**SERVICE BULLETIN**

<sub>N°</sub> 189-273

**DATE:** July 14, 2021

ATA 71 - ENGINE HEATED INTAKE INSTALLATION, FLANGE SEALING

Figure 1

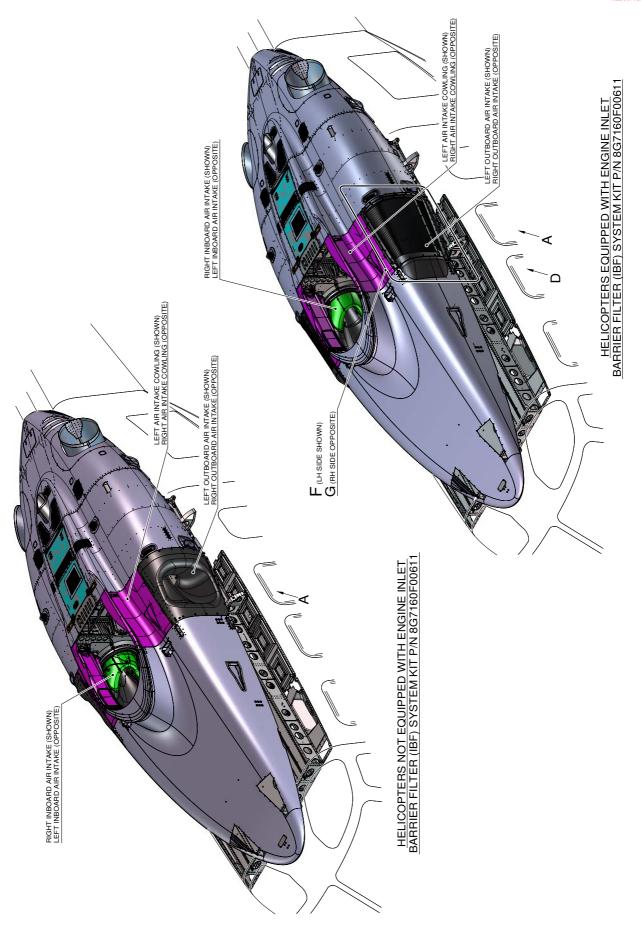
- 2. In accordance with AMP DM 89-A-06-41-00-00A-010A-A, open access doors 451A and 461A.
- 3. In accordance with AMP DM 89-A-71-11-08-00A-520A-A and with reference to Figure 1, remove the LH outboard air intake from the helicopter.

- 4. In accordance with AMP DM 89-A-71-11-10-00A-520A-A and with reference to Figure 1, remove the LH inboard air intake from the helicopter.
- 5. For helicopter S/N 49023 equipped with IBF kit P/N 8G7160F00611, perform the following procedure:

- 7. In accordance with AMP DM 89-A-71-11-08-00A-720A-A and with reference to Figure 1, re-install the LH outboard air intake on the helicopter.
- 8. In accordance with AMP DM 89-A-06-41-00-00A-010A-A, close access doors 461A.

Figure 2

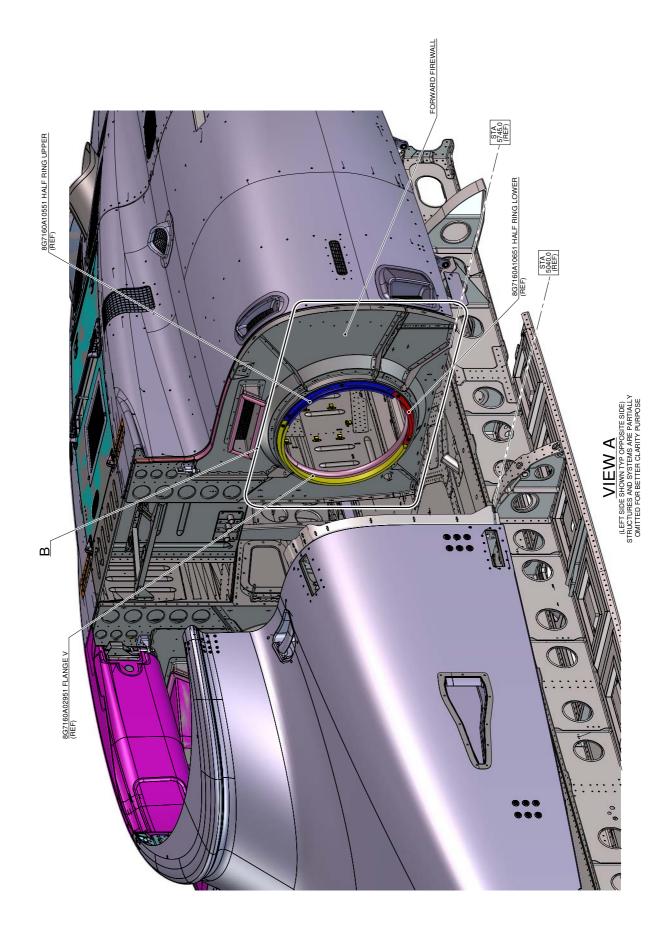
- 6.1 With reference to Figure 2, temporarily remove the half ring lower P/N 8G7160A10651 from forward firewall. Retain existing hardware for later reuse.

- 6.2 With reference to Figure 2, temporarily remove the V flange P/N 8G7160A02951 from forward firewall. Retain existing hardware for later reuse.
  - 6.3 In accordance with AMP DM 89-A-20-10-01-00A-259A-A and with reference to Figure 2, prepare for bonding the surfaces in the working area by removing soluble or non-soluble treatments or cleaning alocromed surfaces.

Figure 3

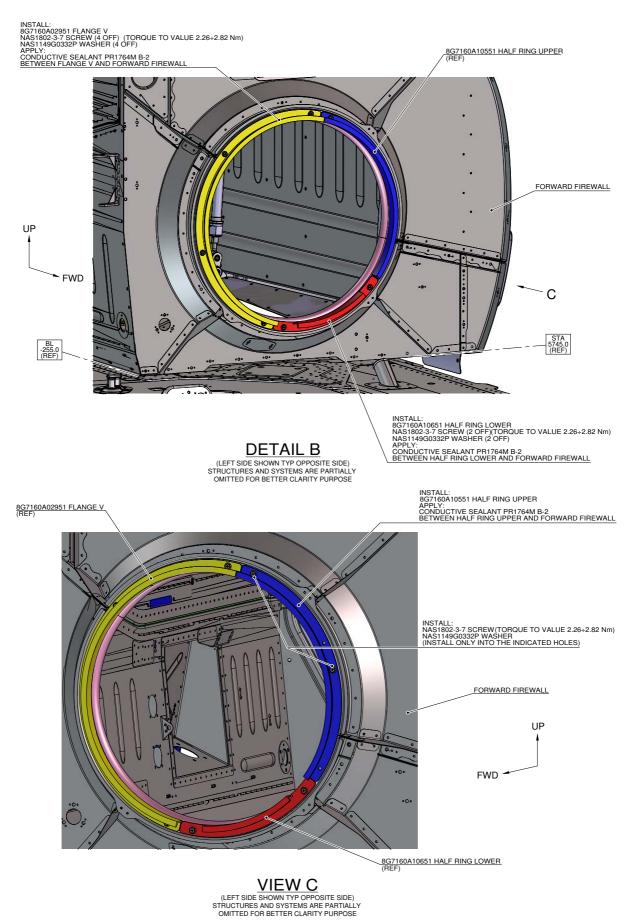
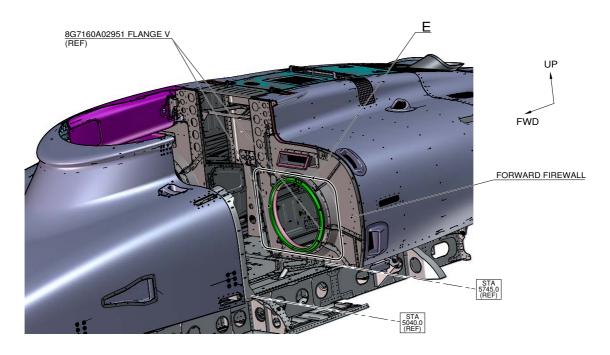
- 6.4 With reference to Figure 3 Detail B, apply conductive sealant PR1764M B-2 (C170) between the V flange P/N 8G7160A02951 and forward firewall. Install the V flange by means of n°4 screws P/N NAS1802-3-7 and n°4 washers P/N NAS1149G0332P.
- 6.5 With reference to Figure 3 Detail B, apply conductive sealant PR1764M B-2 (C170) between the half ring lower P/N 8G7160A10651 and forward firewall. Install the half ring lower by means of n°2 screws P/N NAS1802-3-7 and n°2 washers P/N NAS1149G0332P.
- 6.6 In accordance with AMP DM 89-A-71-11-10-00A-720A-A or DM 89-A-71-11-11-00A-720A-A and with reference to Figure 1, re-install the LH or RH inboard air intake on the helicopter.

- 6.7 With reference to Figure 3 View C and in accordance with applicable steps of AMP DM 89-A-71-11-08-00A-720A-A, apply conductive sealant PR1764M B-2 (C170) between the half ring upper P/N 8G7160A10551 and forward firewall. Install the half ring upper by means of n°2 screws P/N NAS1802-3-7 and n°2 washers P/N NAS1149G0332P.

Figure 4

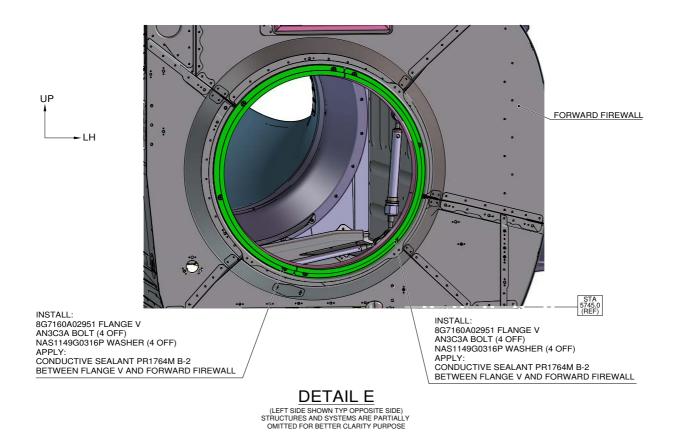
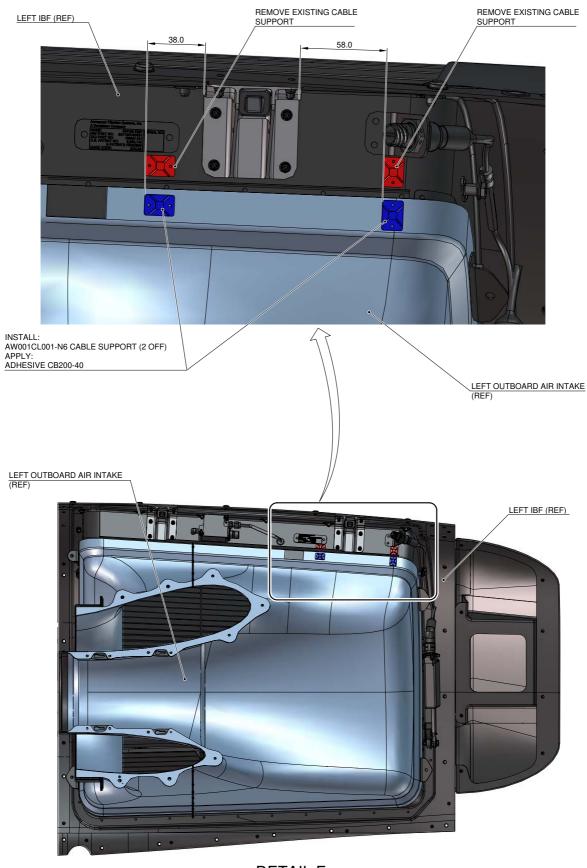
- 5.1 With reference to Figure 4, temporarily remove the V flange P/N 8G7160A02951 from forward firewall. Retain existing hardware for later reuse.
  - 5.2 In accordance with AMP DM 89-A-20-10-01-00A-259A-A and with reference to Figure 4, prepare for bonding the surfaces in the working area by removing soluble or non-soluble treatments or cleaning alocromed surfaces.

- 5.3 With reference to Figure 4 Detail E, apply conductive sealant PR1764M B-2 (C170) between the V flange P/N 8G7160A02951 and forward firewall. Install the V flange by means of n°2 screws P/N NAS1802-3-7 and n°2 washers P/N NAS1149G0332P.
- 5.4 In accordance with AMP DM 89-A-71-11-10-00A-720A-A or DM 89-A-71-11-11-00A-720A-A and with reference to Figure 1, re-install the LH or RH inboard air intake on the helicopter.

- 5.5 With reference to Figure 4 Detail E and in accordance with applicable steps of AMP DM 89-A-71-11-08-00A-720A-A, apply conductive sealant PR1764M B-2 (C170) between the V flange P/N 8G7160A02951 and forward firewall. Install the V flange by means of n°2 screws P/N NAS1802-3-7 and n°2 washers P/N NAS1149G0332P.

Figure 5

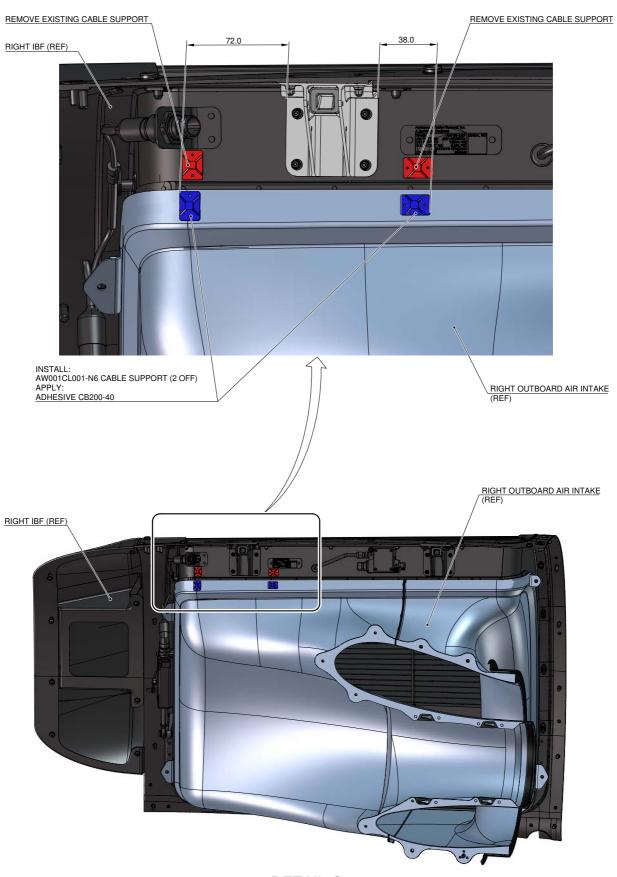
- 5.6 With reference to Figure 5 Detail F, remove n°2 existing cable supports from the LH IBF. Refer to Figure 6 Detail G for RH IBF.
- 5.7 With reference to Figure 5 Detail F, install n°2 cable supports P/N AW001CL001-N6 by means of adhesive CB200-40 (C356) on the LH outboard air intake. Refer to Figure 6 Detail G for RH IBF.
